# Blue Print Bulletin

## Toyota Carina E and Avensis Water Pumps

ADT39145 (Aisin) & ADT39177 (SEM) - 7AFE 1.8 engine

Date Issued: 01/07/02

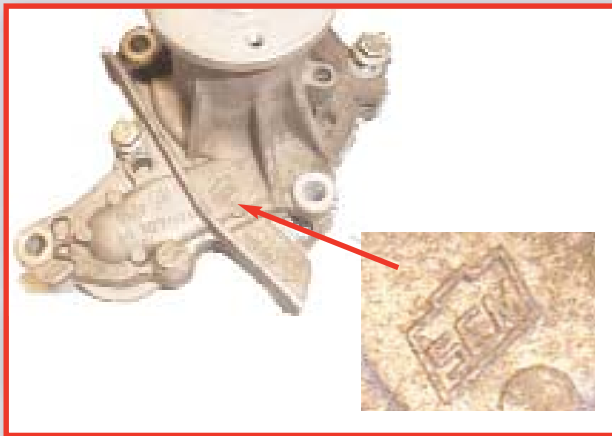
**The ADT39143 and ADT39145 pumps will contain the front casing only, and must only be fitted to the Aisin type rear casing.** If fitted to an SEM type rear casing, the retaining bolts will not fit correctly and water will leak from the gasket.

**If you are unable to identify the manufacturer of the water pump to be replaced, ADT39159 and ADT39177 are supplied complete with front and rear casings pre-assembled. These part numbers will replace all manufacturers.**

**The original SEM type pump** can be identified by the manufacturer's mark on the outer casing (see picture)

Side profile of the replacement SEM type pump with the front and rear casings pre-assembled.
